**MASTER PLAN AND SITE PLAN AND DESIGN REVIEW
QUASI-JUDICIAL LAND USE DECISION (TYPE III)
STAFF REPORT AND RECOMMENDATION TO THE PLANNING COMMISSION**

May 12, 2015

FILE NUMBER: CP 14-03: Master Plan
DP 14-04: Detailed Development Plan
NR 14-10: Natural Resource Review

REQUEST: The applicant has submitted a Master Plan, Detailed Development Plan, and Natural Resource Overlay Review for a Master Plan for the Moss High School Campus to include the existing high school, ball fields, and a new transportation maintenance facility. The vacant 10.5 acre portion of the site is proposed to accommodate the District's Transportation and Maintenance Facility and associated parking areas for buses, vans, maintenance vehicles and Transportation and Maintenance Staff and visitor parking.

Figure 4: Proposed Detailed Development Plan for the Transportation Maintenance Facility

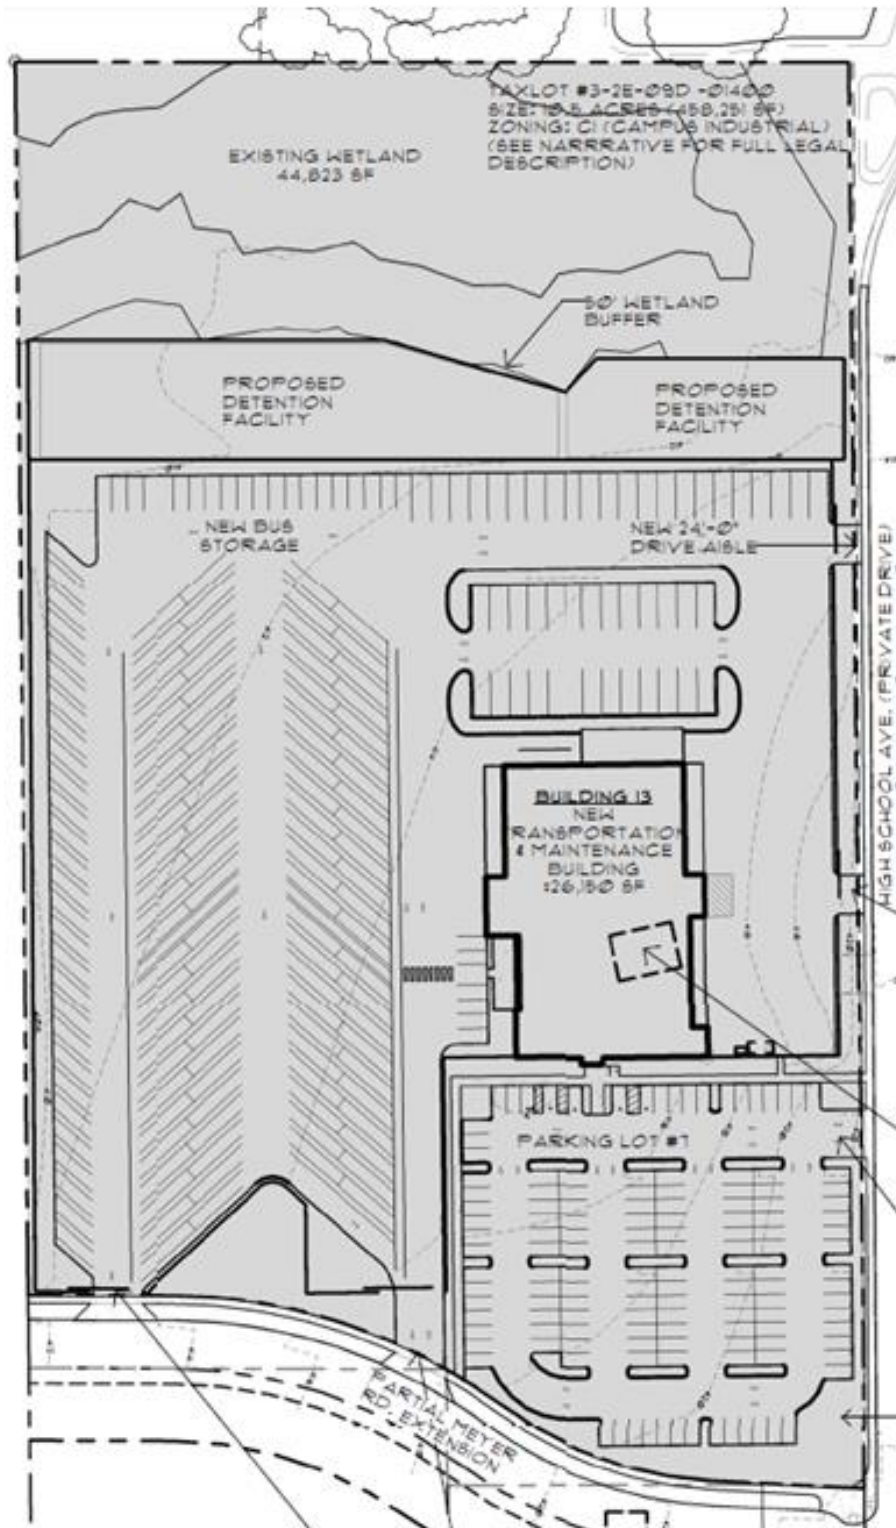
36. The applicant shall reconfigure the site design such that no portions of the parking lot are within the 20 foot setback along Meyers Road. (P)
37. The applicant shall make the parking lot available to the public after hours, as proposed, and shall provide visible signage that identifies the hours during which the lot is available for public use and directs drivers to the parking lot entrance. (P)

54. Prior to issuance of building permits, the applicant shall revise the site plan to demonstrate that 40 carpool/vanpool spaces will be provided at the high school as part of this detailed development plan. (P)

61. The applicant shall provide trees every 35 feet along the pedestrian walkway on the west side of the parking lot. (P)
62. Prior to issuance of permits, the applicant shall confirm that the loading standards set forth in Code Section 17.52.090 is not applicable or provide documentation showing compliance with loading requirements. (P)

66. The applicant shall provide a revised tree removal plan that separates trees in construction area from trees outside of the area, and preserves all trees outside of the construction area to the extent practicable. The applicant shall make an attempt to reduce the size of the parking lot and modify the overall site layout to preserve trees. (P)
